LAUREL BAY GARDENS

LCB # 6710

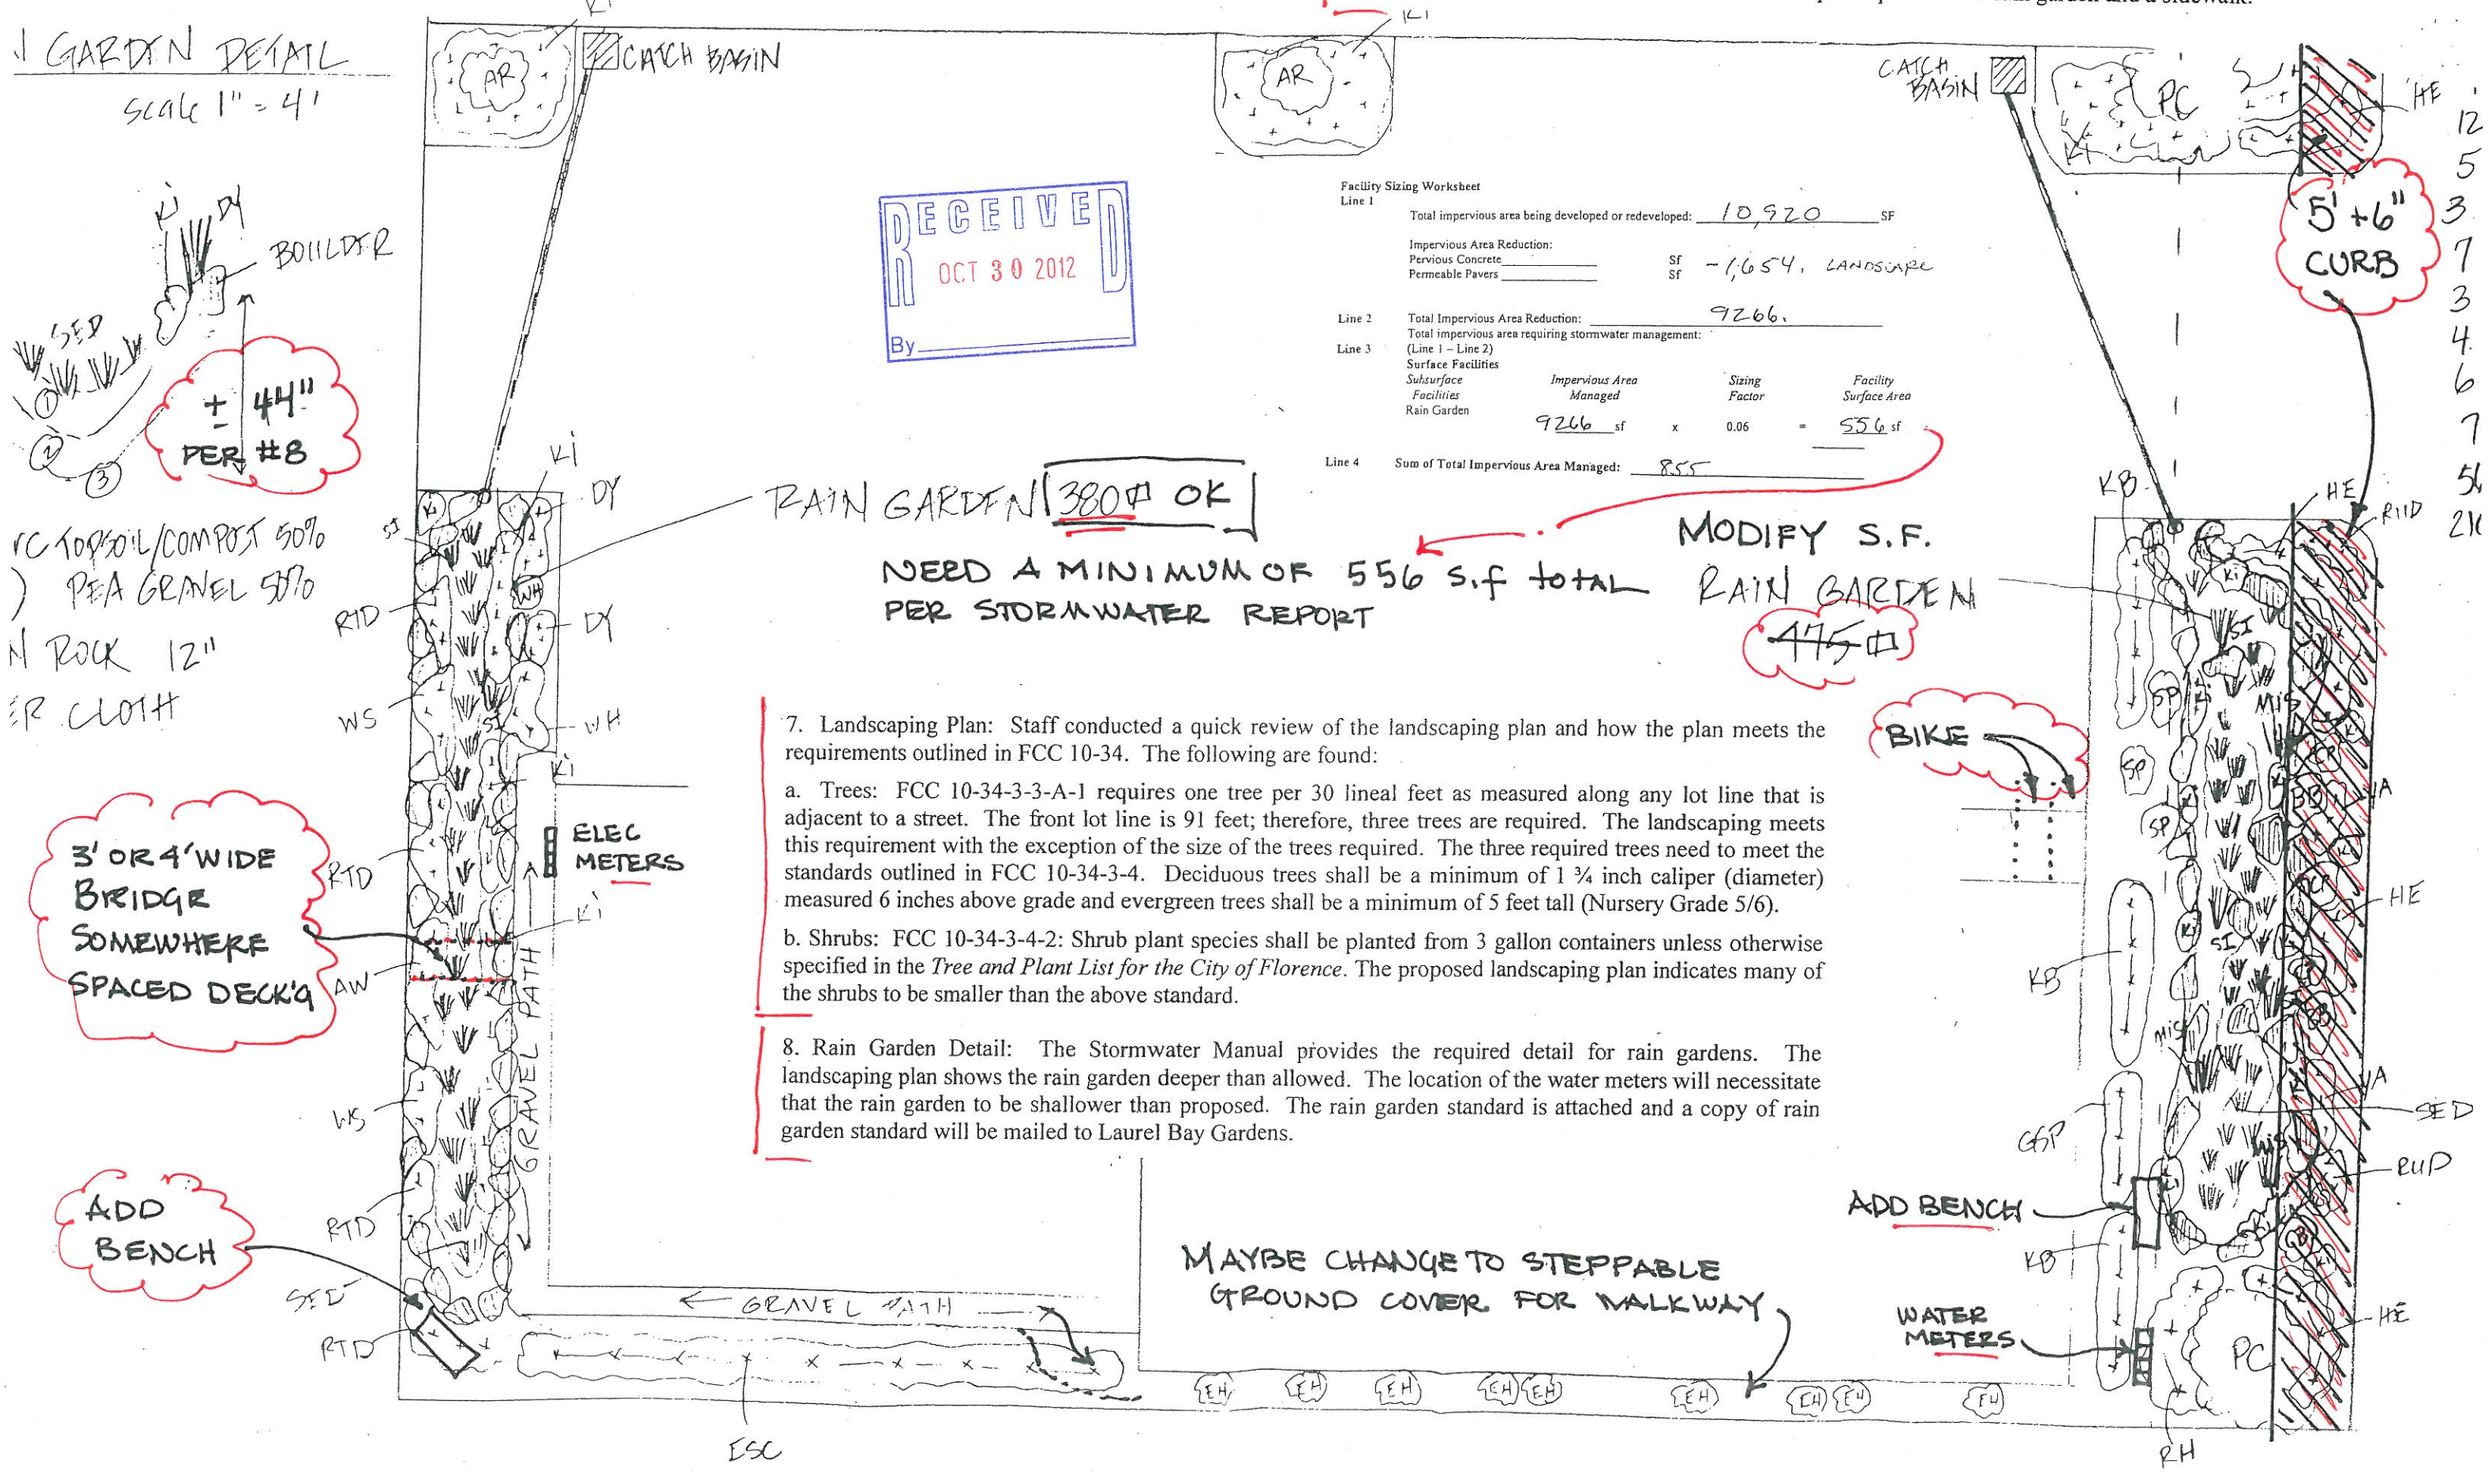
3. FCC 10-36-2-16-A also states that sidewalks may be placed adjacent to the street or at the property line with planter strips where practicable, or as otherwise directed by the Public Works Director. The submitted landscaping plan indicates that one of the rain gardens will be installed within the right-of-way. The installation of a sidewalk will affect the rain garden as shown on the landscaping plan. The landscaping plan will need to be amended to show that there is adequate space for the rain garden and a sidewalk.

a. Trees: FCC 10-34-3-3-A-1 requires one tree per 30 lineal feet as measured along any lot line that is adjacent to a street. The front lot line is 91 feet; therefore, three trees are required. The landscaping meets this requirement with the exception of the size of the trees required. The three required trees need to meet the standards outlined in FCC 10-34-3-4. Deciduous trees shall be a minimum of 1 ¾ inch caliper (diameter) measured 6 inches above grade and evergreen trees shall be a minimum of 5 feet tall (Nursery Grade 5/6).

b. Shrubs: FCC 10-34-3-4-2: Shrub plant species shall be planted from 3 gallon containers unless otherwise specified in the *Tree and Plant List for the City of Florence*. The proposed landscaping plan indicates many of the shrubs to be smaller than the above standard.

8. Rain Garden Detail: The Stormwater Manual provides the required detail for rain gardens. The landscaping plan shows the rain garden deeper than allowed. The location of the water meters will necessitate that the rain garden to be shallower than proposed. The rain garden standard is attached and a copy of rain garden standard will be mailed to Laurel Bay Gardens.
